Lighthorse Interchange Business Hub VMP

Charter Hall

Project Name	Lighthorse Interchange Business Hub VMP
Project Number	21GWS20284
Project Manager	Bonnie Simeonov
Prepared by	Strini Pillai
Reviewed by	Andrew Whitford
Approved by	Andrew Whitford
Status	Final
Version Number	V4
Last saved on	21 January 2022

Figure 2: Plant Community Types

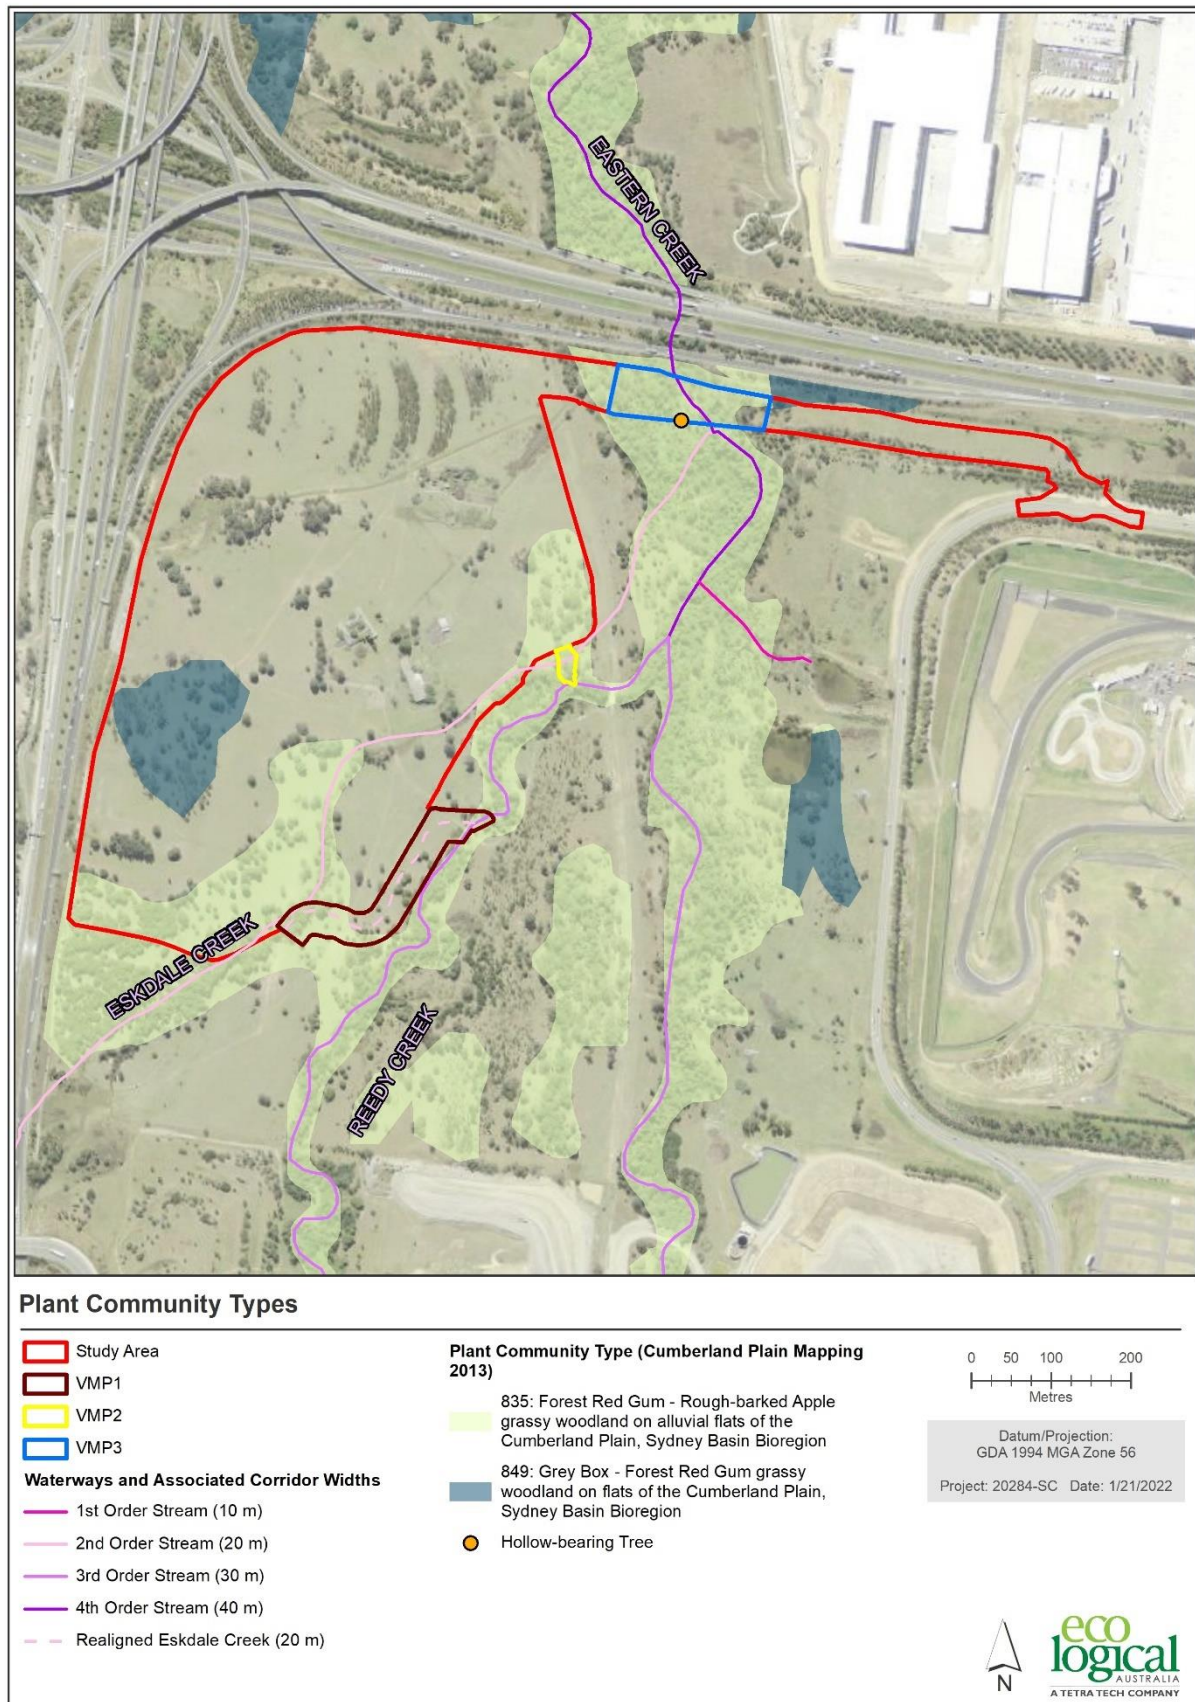
Comparing Figure 4.3 in the BDAR with Figure 4 in the draft VMP shows there are hollow bearing trees in proximity to the VMP3 area.

Comparing Figure 4.3 in the BDAR with Figure 4 in the draft VMP shows there are hollow bearing trees in proximity to the VMP3 area.

Table 19: Implementation schedule

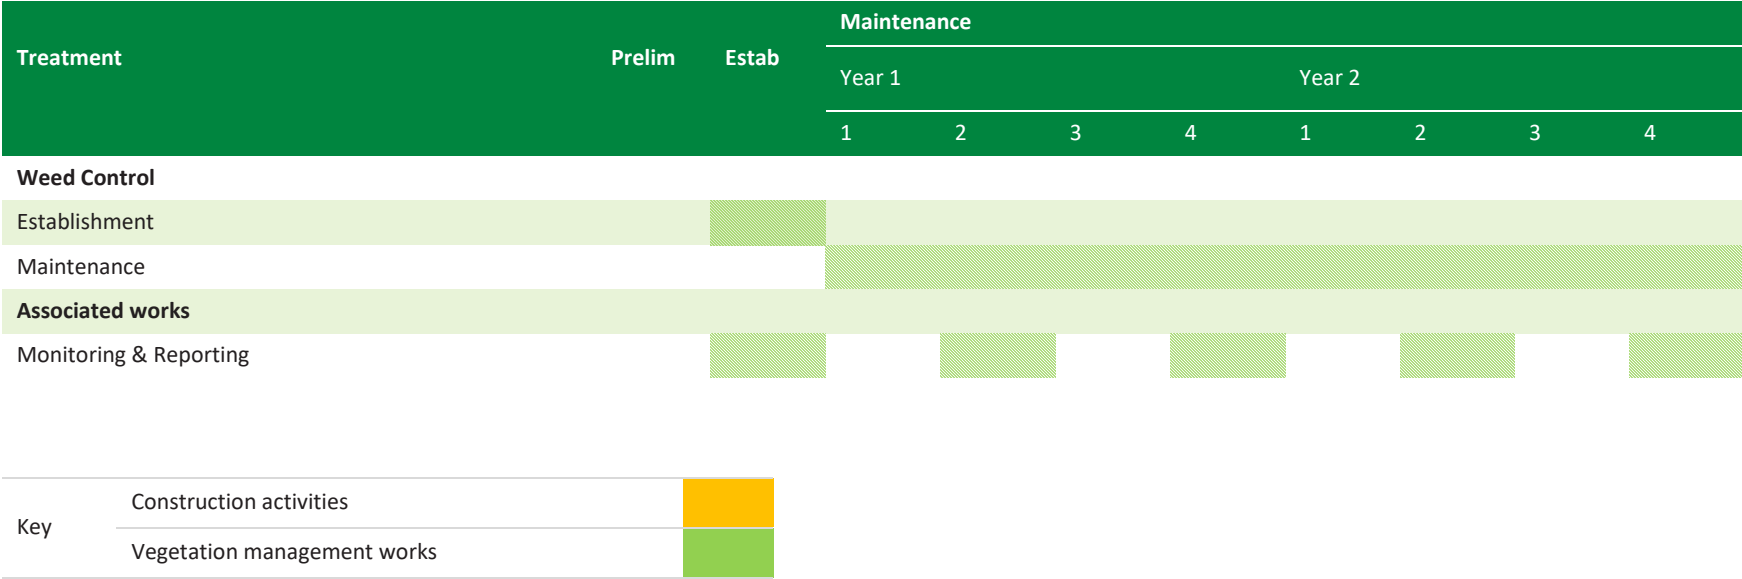
Table 17 lists seed collection and clearing under 'Revegetation' but seed collection should be undertaken prior to any clearing of vegetation. Seed collected prior to clearing should be propagated so that plants are available for revegetating the VMP areas and elsewhere on the site and it is recommended Table 17 specifies this.

Schedule revised to include pre-clearance survey, plans and clearing timing.

Seed collection addressed in 3.1.3 and in the schedule.
